# Addendum

**Project:** Harris County Psychiatric Center Renovation  
Units 1C, 2E, 3B, 3C, 3D, & 3E

**Addendum No.:** 002

**Date:** November 14, 2016

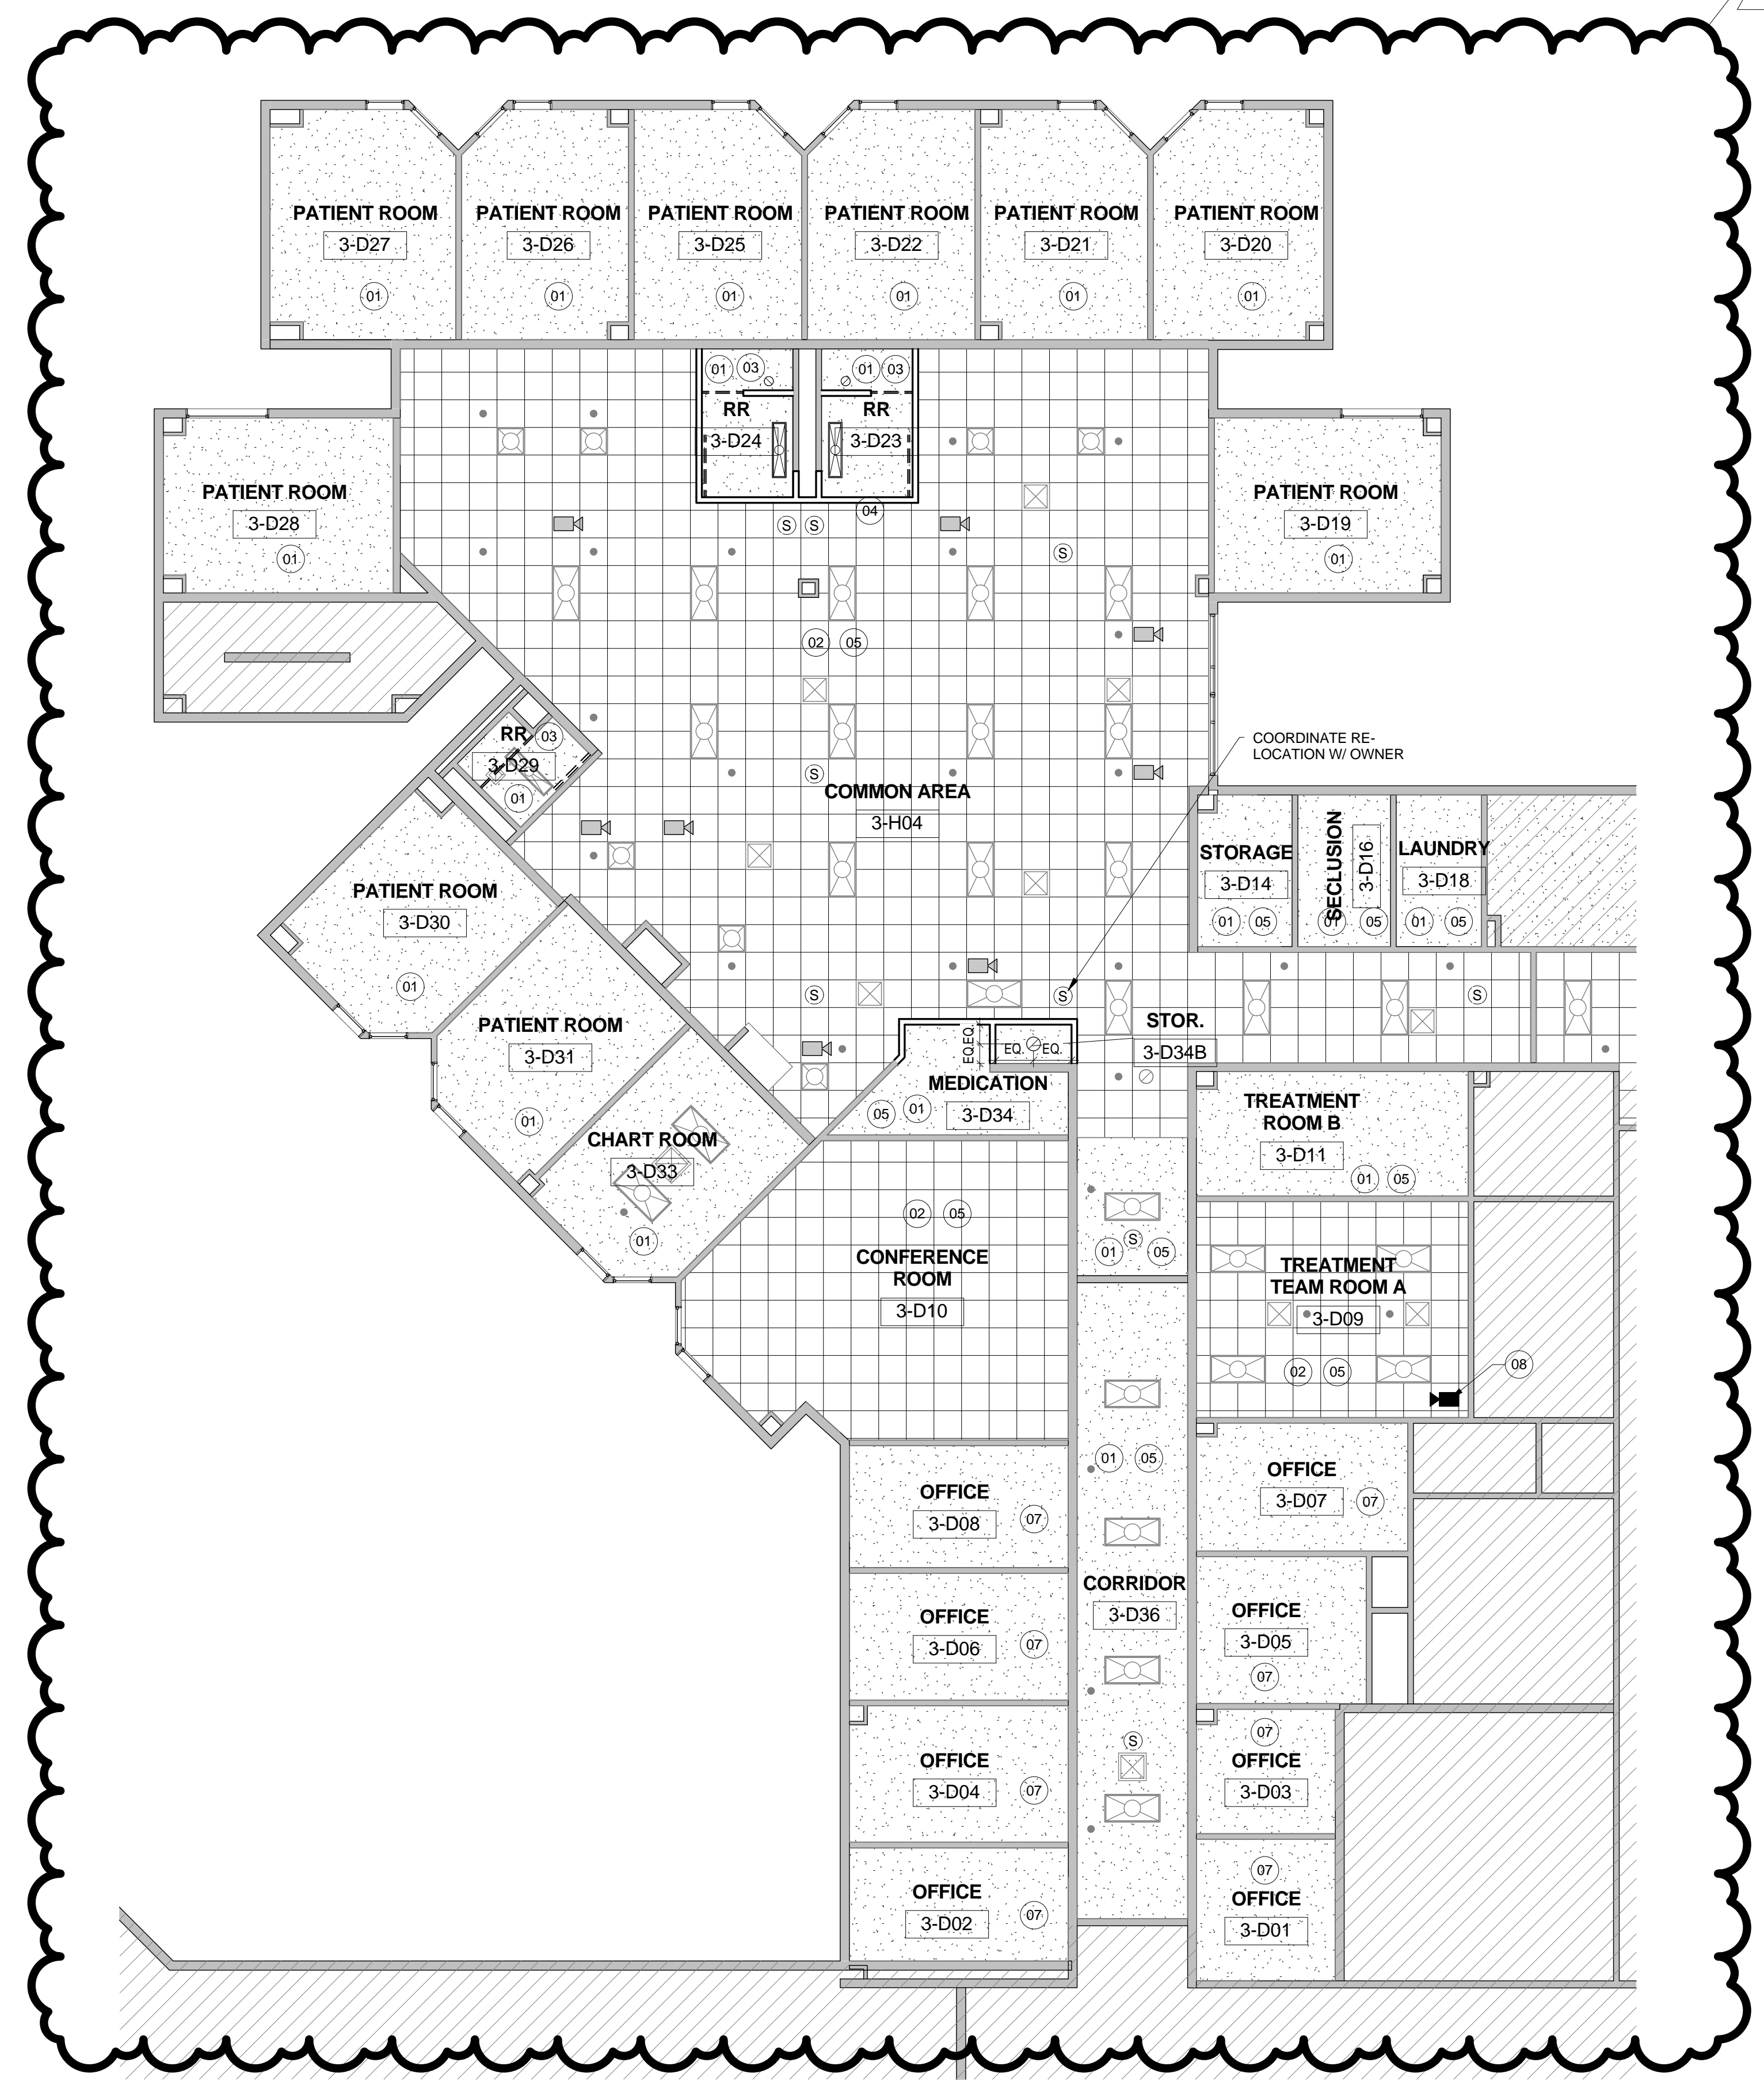
19. Sheet A10.05, Reflected Ceiling Plan – Unit 3D Third Floor, revised to reflect changes to keyed note text and placement on the reflected ceiling plan in order to provide additional clarification regarding the scope of work pertaining to existing and new light fixtures throughout the unit. (see attached)
